| Project Title: | Palmdale Hybrid Power Project - Compliance |
| Document Title: | Palmdale Energy, LLC's Petition for Amendment |

PALMDALE ENERGY PROJECT

**Subject: PALMDALE ENERGY, LLC'S PETITION FOR AMENDMENT
PALMDALE HYBRID POWER PROJECT
DOCKET NO. (08-AFC-9C)**

FIGURE 2-1

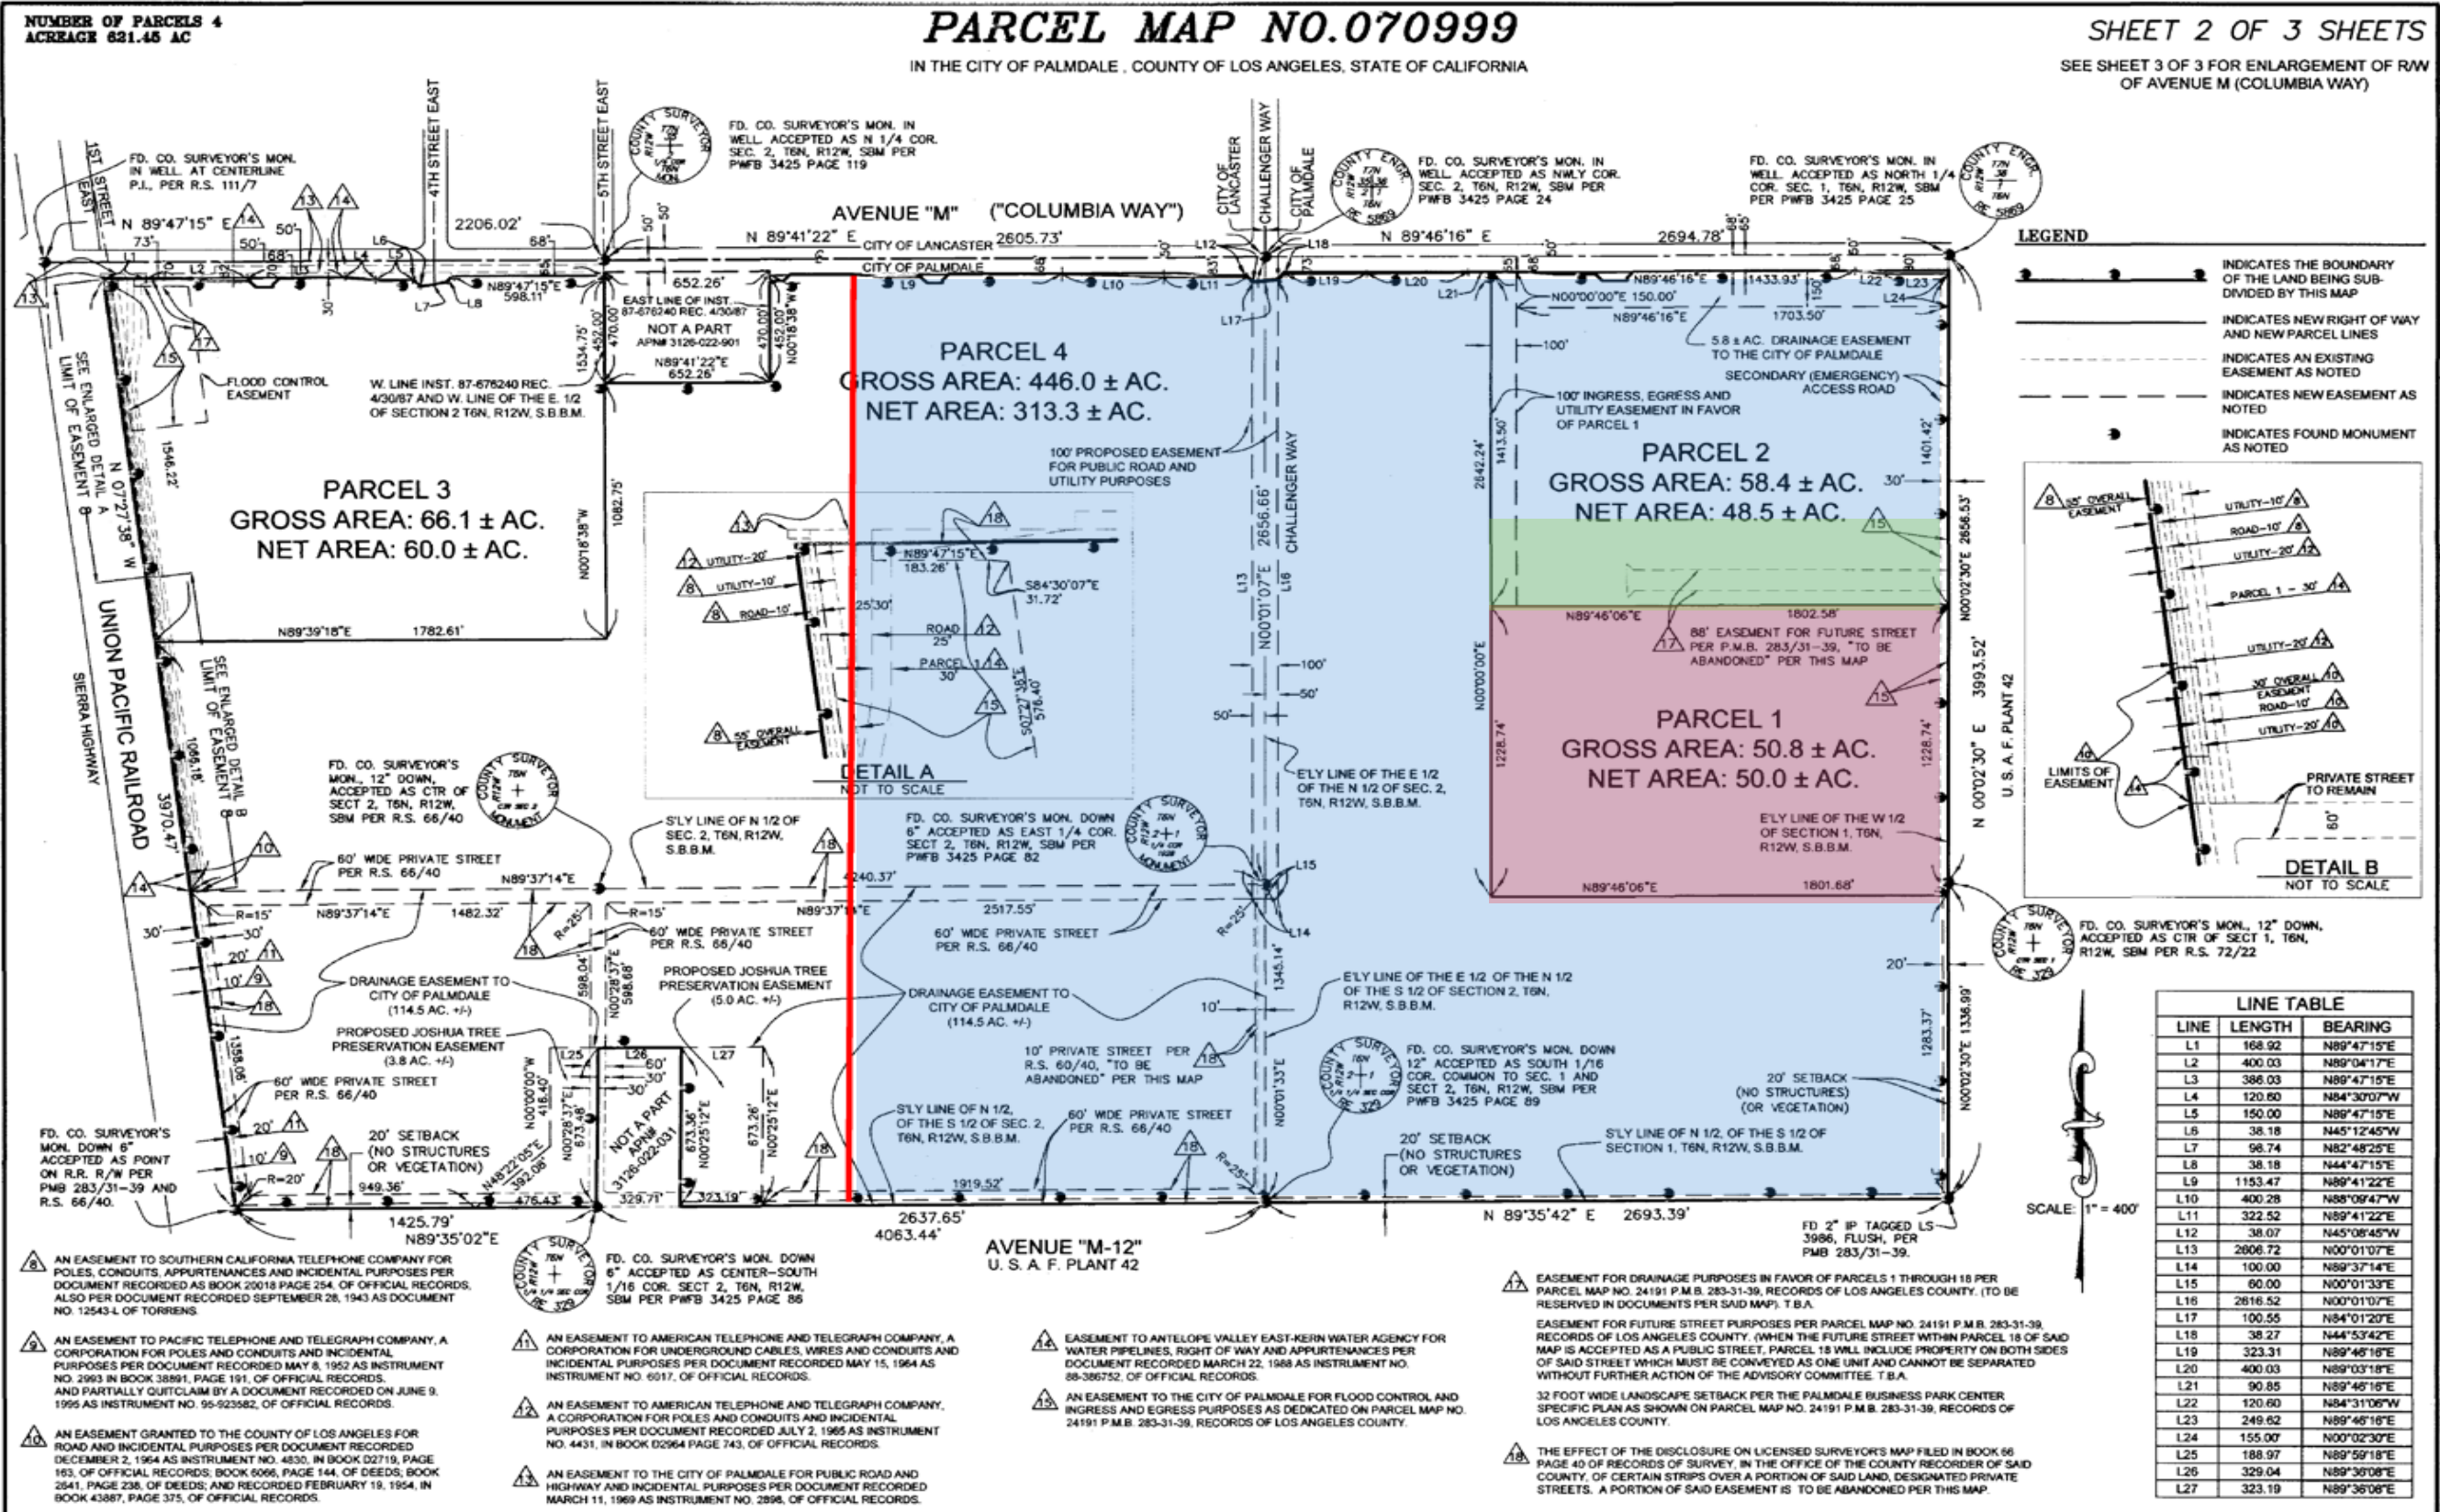
1. Trucking water from the PWRP to the Plant until the Modified Project is connected to a reclaimed water pipeline.
2. Interconnection to the existing reclaimed water pipeline located at near the intersection of Sierra Highway and East Avenue M which is along the is proposed, reclaimed water pipeline route see (see Figure 2-1).
3. Through the construction of a new 7.4 mile reclaimed water pipeline which would connect the PWPP and AWWTP. The pipeline will be installed in existing City street ROWs primarily within the City of Palmdale, although a small portion of the pipeline in the immediate area of the PWRP is in unincorporated Los Angeles County (see Figure 2-1).

Since the time of issuance of the Final License, the City of Palmdale constructed an 18-inch sewer pipeline along the south side of East Avenue M. The Modified Project will now interconnect with this sewer pipeline instead of the pipeline that was located along Avenue L. The Modified Project will install a 0.25-mile, six to twelve-inch sanitary wastewater pipeline from the PEP plant site to a connection point at the intersection the project access road and East Avenue M, as shown on Figure 2-1.

A 20-acre temporary construction laydown and parking area will be provided, as shown on Figure 2-1. The temporary construction laydown and parking area will be restored after use. The construction sequence for power plant construction includes the following general steps:

FIGURE 2-2 PARCEL MAP - SITE AND LAYDOWN

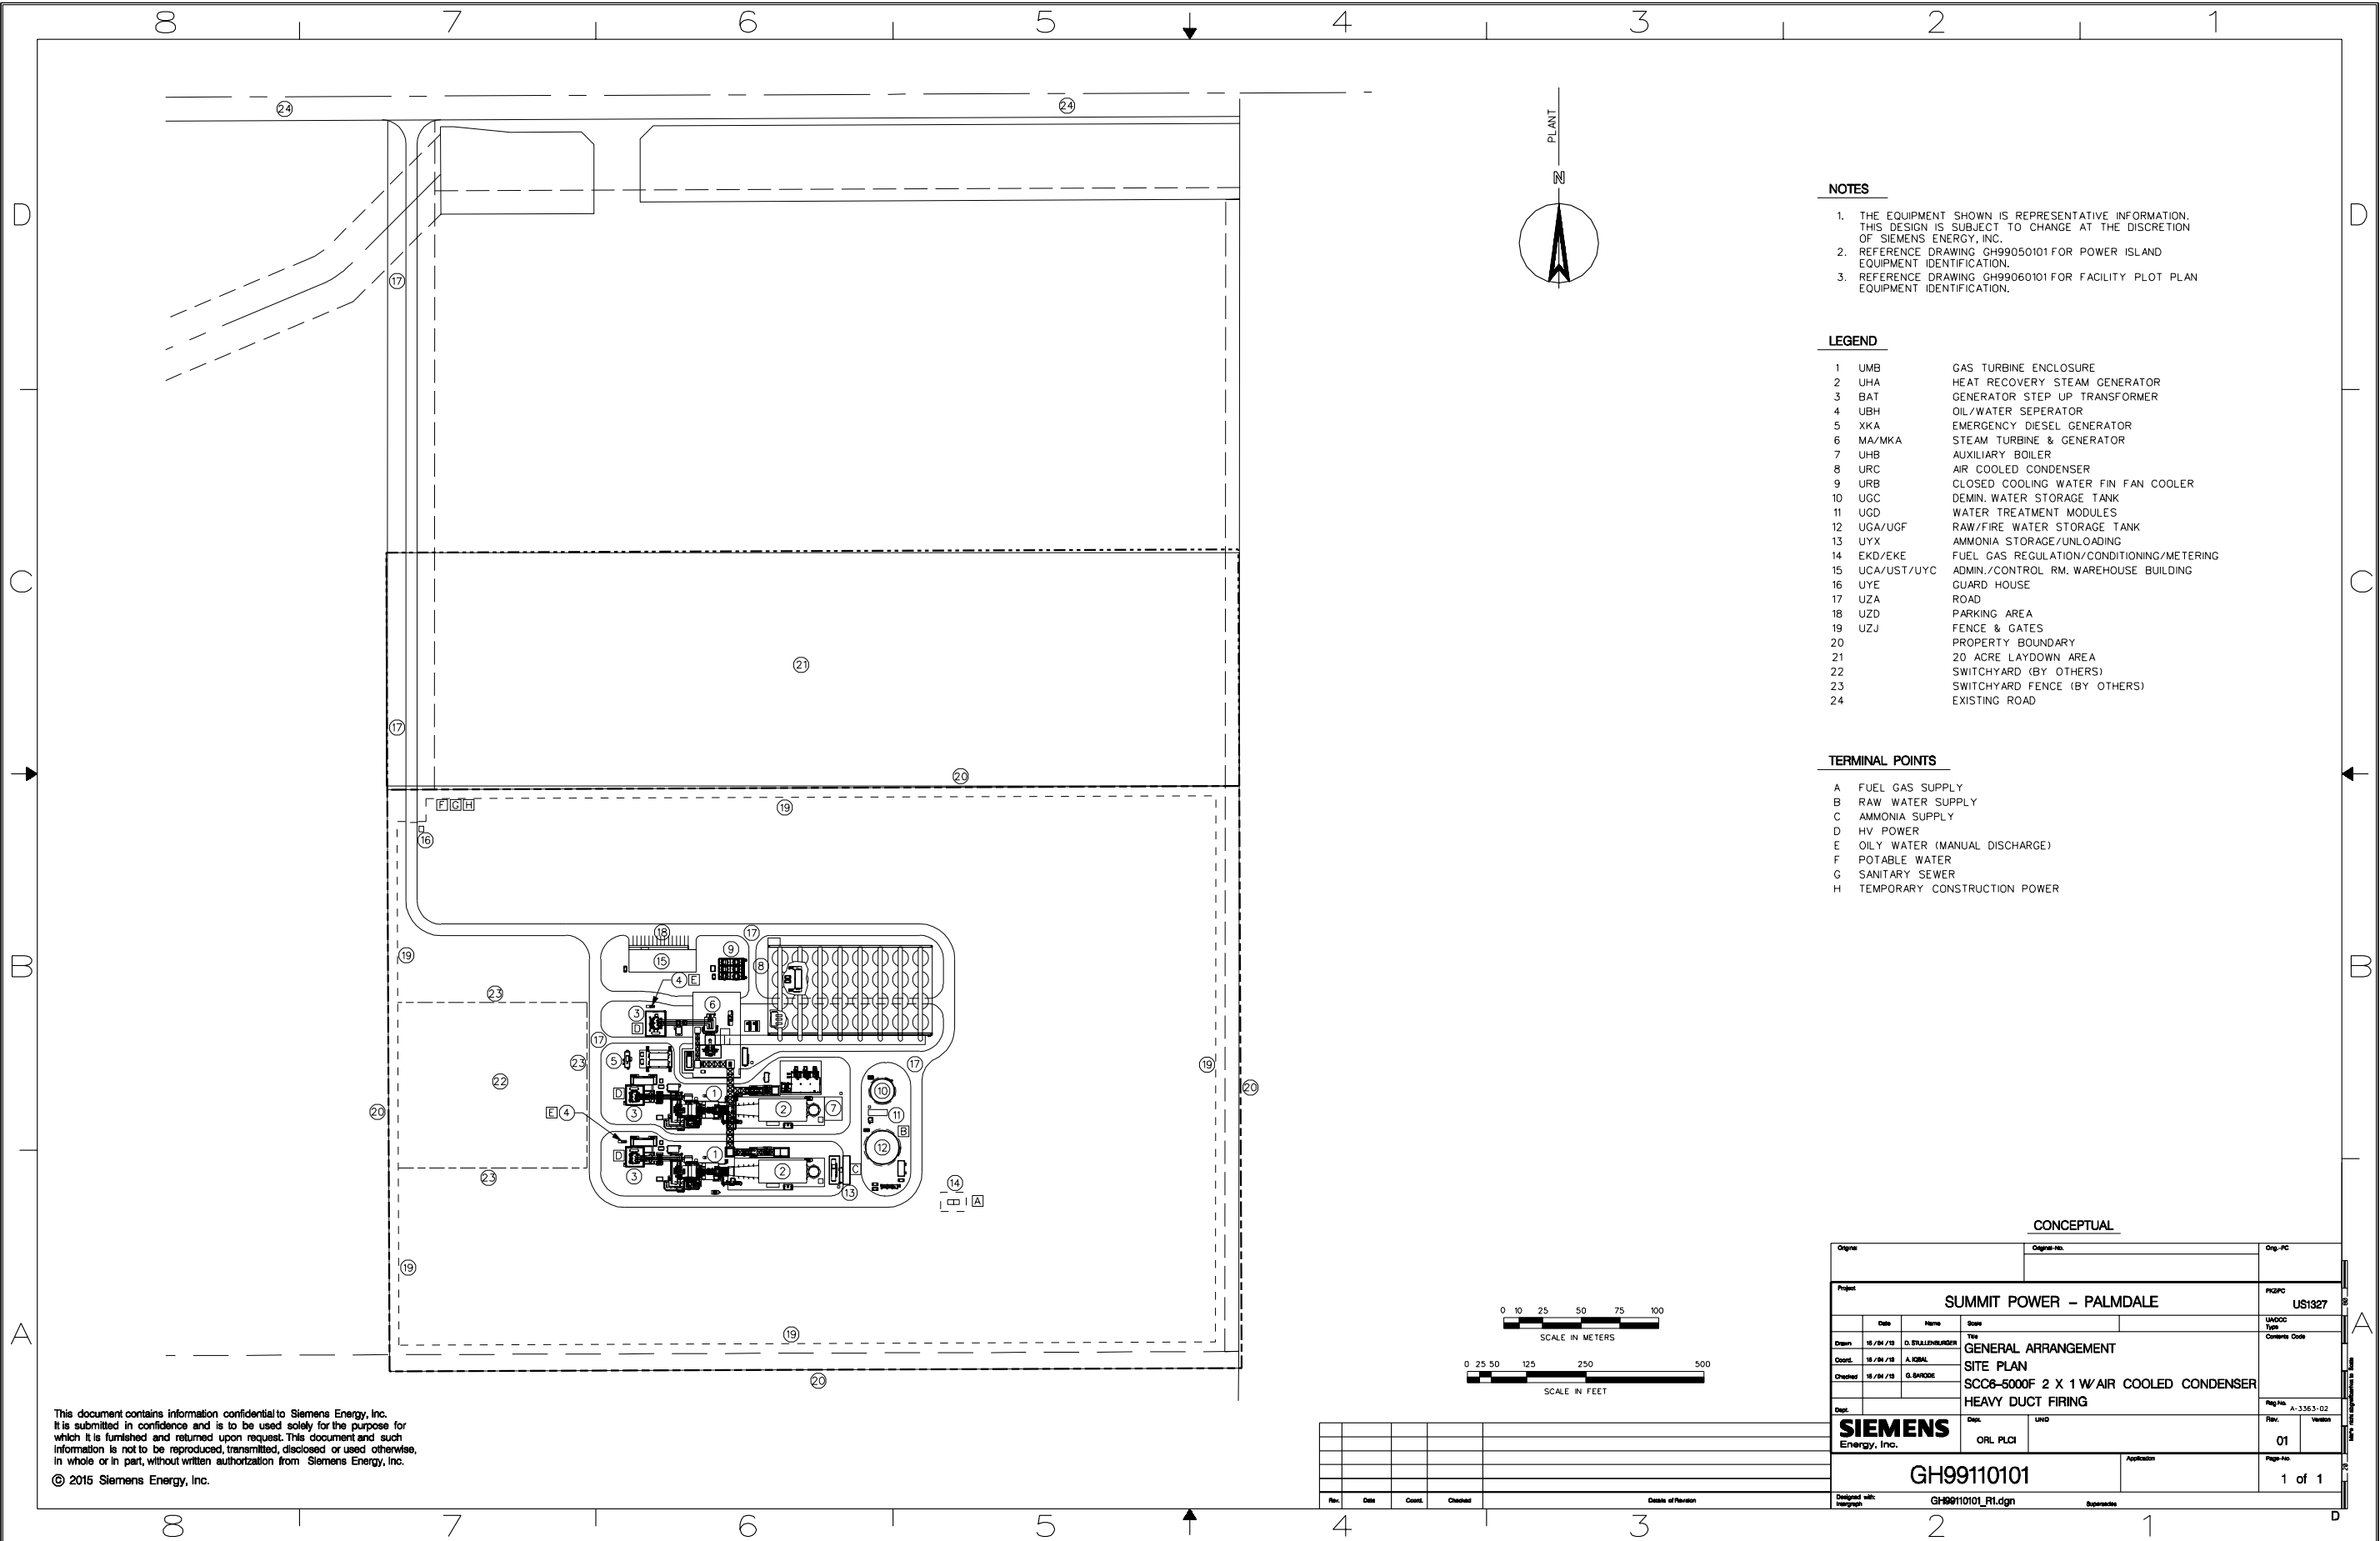
The only change relevant to land use is the parcel split that was performed by the City of Palmdale to create a new parcel encompassing 50 acres for the Modified Project. Figure 2-2 provides the parcel map and Appendix 6-A provides formal documentation that the City of Palmdale has officially approved the parcel split. There are no other modifications that would require further analysis in Land Use for the Modified Project.
